COUNCIL ASSESSMENT REPORT
SYDNEY EASTERN CITY PLANNING PANEL

PANEL REFERENCE & DA NUMBER	PPSSEC-304 – DA/2023/1125
PROPOSAL	Integrated development for construction of a two-storey community facility including rowing boatshed, public boat launching pontoon, kiosk and ancillary spaces.
ADDRESS	Part Lot 120 DP 1279860 – 66-68 Mary Street LILYFIELD
APPLICANT	Barbara Ramjan
OWNER	Crown Lands
DA LODGEMENT DATE	27 December 2023
APPLICATION TYPE	Development Application (Integrated)
REGIONALLY SIGNIFICANT CRITERIA	Section 2.19(1) and Clause 5 of Schedule 6 of <i>State Environmental Planning Policy (Planning Systems) 2021</i> declares the proposal regionally significant development as: Private infrastructure and community facilities over \$5 million
CIV	\$9,350,821 (excluding GST)
CLAUSE 4.6 REQUESTS	N/A
KEY SEPP/LEP	<ul style="list-style-type: none"> • <i>State Environmental Planning Policy (Biodiversity and Conservation) 2021</i> • <i>State Environmental Planning Policy (Sustainable Buildings) 2022</i> • <i>State Environmental Planning Policy (Planning Systems) 2021</i> • <i>State Environmental Planning Policy (Resilience and Hazards) 2021</i> • <i>State Environmental Planning Policy (Tra

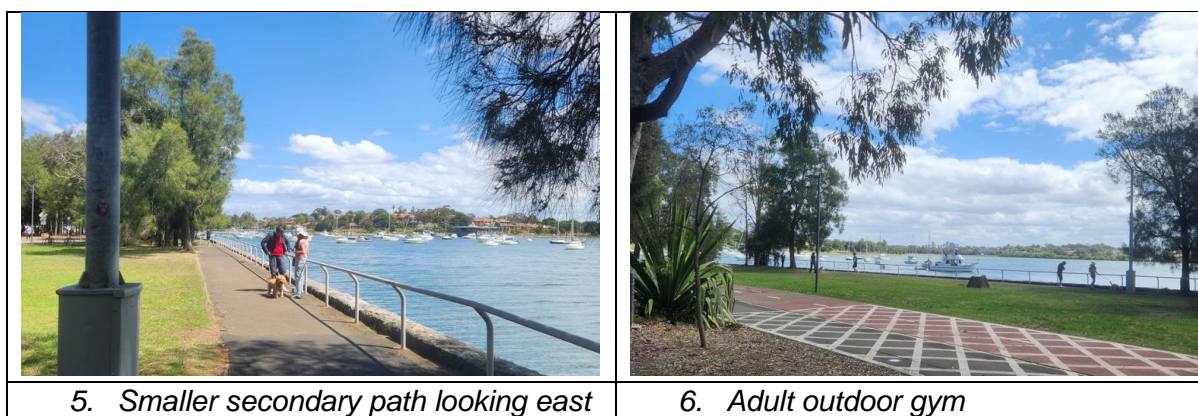
The third step is to identify the extent of the obstruction at each relevant location

Using the criteria set out in appendix D, it is observed that the location of views impacted will be from a flat foreshore, and therefore viewers will have no view over the structure. All viewpoints are within 100m of the adjoining shoreline, and the period of people engaging with the view will range between a few minutes to half a day from all locations. The scale of the development is best categorised as being 10-30m. Iron Cove is considered a narrow and enclosed bay as the mouth is narrower than its widest part. As such, considering the 6 viewpoints identified within the foreshore, the development can be considered high impact.

**Figure 14: Except from Proposed Public Domain Improvement Plan (ASK1.10 rev A,
Source: Hill Thalís)**

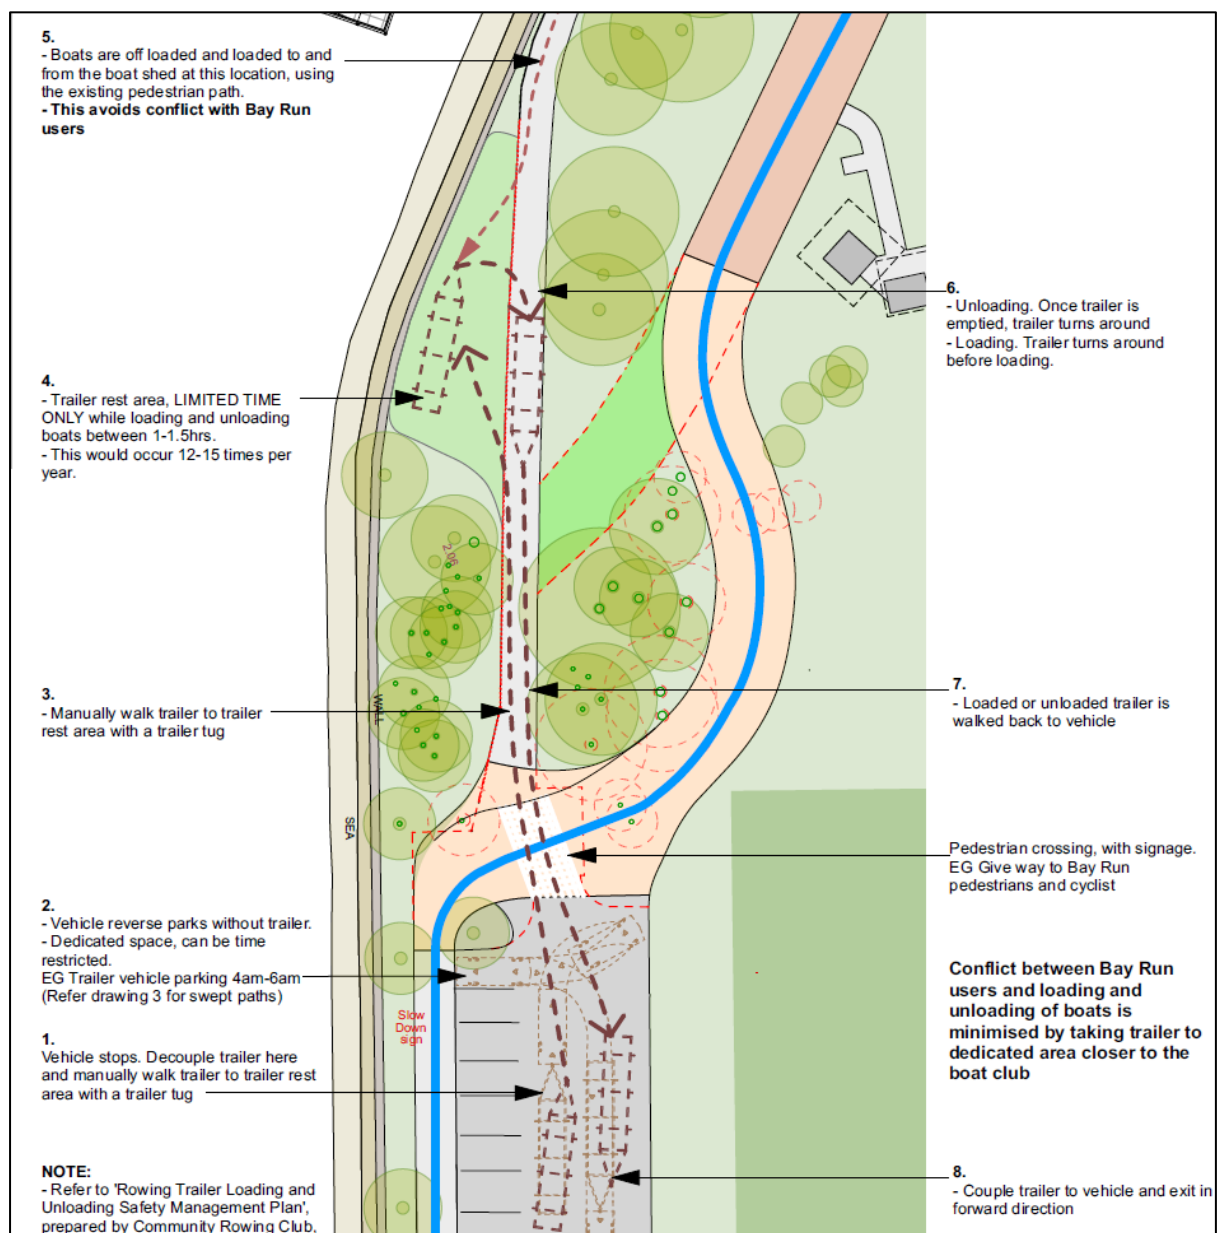
Whilst the public domain improvement plan positively provides separation of uses, the plan overall is not considered appropriate for the following reasons:

- The loading/unloading of boat trailers within the parkland requires 'reinforcing' part of the public grassed area for a temporary storage area and/or would result in adverse environmental impacts including soil erosion, and damage to vegetation and trees.
- The loading/unloading of boat trailers within the parkland could result in public safety issues such as blocked access paths. This would require clearly dimensioned plans and swept paths.
- The path to the loading/unloading zone has not demonstrated sufficient width for a trailer. This would require clearly dimensioned plans and swept paths.
- The loading/unloading and temporary storage of boat trailers within this portion of the parkland will detract from the natural and scenic qualities which would affect the recreational enjoyment for others.

Notwithstanding, the public domain improvement plan or plan of management has not sufficiently addressed how the other associated uses on the site will operate to minimise conflict, including;

It is considered that these matters can be resolved, however need to be resolved prior to determination given the uncertainties in relation to the possible impacts of the development on the public domain. In the event of approval, a deferred commencement condition could be imposed to ensure a revised public domain plan is developed to protect Leichhardt Park. Further, in the event of an approval, a deferred commencement condition would be sought for the plan of management to be amended to address the whole proposal.
